[Docket No. 2003-CE-43-AD; Amendment 39-13328; AD 2003-20-10]

**Airworthiness Directives; Raytheon Aircraft Company Beech Models 1900, 1900C, and 1900D Airplanes**

**ACTION:** Final rule; request for comments.

Figure 1

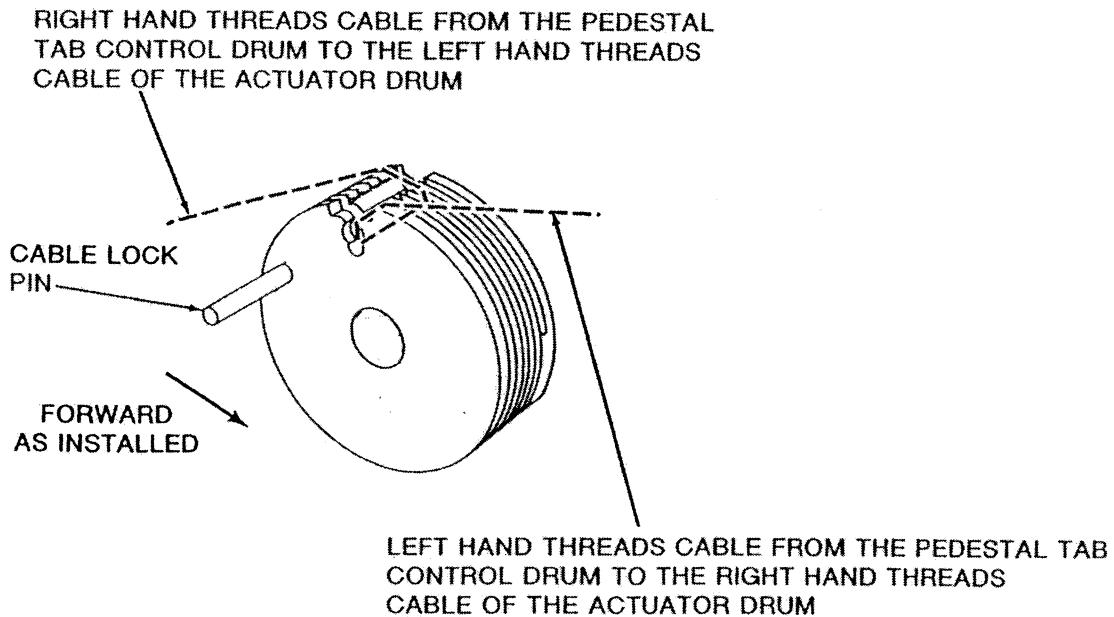
- The figures in the applicable maintenance manuals depict the elevator trim cable drum at 180 degrees from the installed position and show the open, keyed side of the drum instead of the flat side of the drum. Following these figures when installing the control cables on the forward control cable drum could reverse the action of the elevator manual trim system; and
- The existing procedure can be enhanced by visually confirming the trim wheel position and the trim tab position are consistent. Such a check would detect and correct any problems with the elevator trim system installation before problems occur during operation.

Although the figures (figure 9 for the 1900/1900C and figure 201 for the 1900D) in the existing maintenance manuals are incorrectly depicted, following the step-by-step written instructions in the existing procedure and referring to the orientation of the parts removed would result in the correct installation and action of the elevator trim system.

Actions	Compliance	Procedures
<p>(1) Using pen and ink, mark the applicable figure in the maintenance manual as referenced below. The depiction in the referenced figures is incorrect for the elevator trim drum only and depicts the cable drum at 180 degrees from the installed position and shows the open, keyed side of the drum instead of the flat side of the drum. Insert corrected figure (Figure 1 of this AD) into the applicable maintenance manual and identify it accordingly:</p> <ul style="list-style-type: none"> <li>(i) Figure 9 of Chapter 27-10-00 of the Model 1900/1900C Airliner Maintenance Manual (114-590021-7B) Clearly note in pen that existing portion of Figure 9 is correct for the aileron trim drum only and insert corrected figure (Figure 1 of this AD) marked in pen as correct for the elevator trim drum only; or</li> </ul>	<p>Before the next time you have maintenance done on the elevator trim system.</p>	<p>As specified in Raytheon Safety Communiqué No. 234, dated September 2003.</p>

Actions	Compliance	Procedures
<p>(ii) Mark out Figure 201 of Chapter 27-30-04 of the Model 1900D Airliner Maintenance Manual (125-590000-15). Insert corrected figure (Figure 1 of this AD)</p> <p>(2) Incorporate the applicable temporary revision into the maintenance manuals as follows:</p> <p>(i) Temporary Revision No. 27-5 to the Model 1900/1900C Airliner Maintenance Manual: Revised ELEVATOR TRIM OPERATIONAL CHECK; or</p> <p>(ii) Temporary Revision No. 27-9 to the Model 1900D Airliner Maintenance Manual: Added MANUAL ELEVATOR TRIM OPERATIONAL CHECK.</p> <p>(3) Do the elevator trim operational check that is specified in the applicable maintenance manual and temporary revisions to the maintenance manual as referenced in paragraph (e)(2) of this AD</p>	<p>Before the next time you have maintenance done on the elevator trim system.</p> <p>Prior to further flight after each time you have maintenance done on the elevator trim system.</p>	<p>As specified in Raytheon Safety Communiqué No. 234, dated September 2003.</p> <p>As specified in Raytheon Safety Communiqué No. 234, dated September 2003; and Temporary Revision No. 27-5 to the Model 1900/1900C Airliner Maintenance Manual: Revised ELEVATOR TRIM OPERATIONAL CHECK; or Temporary Revision No. 27-9 to the Model 1900D Airliner Maintenance Manual: Added MANUAL ELEVATOR TRIM OPERATIONAL CHECK, both dated September 12, 2003, as applicable.</p>
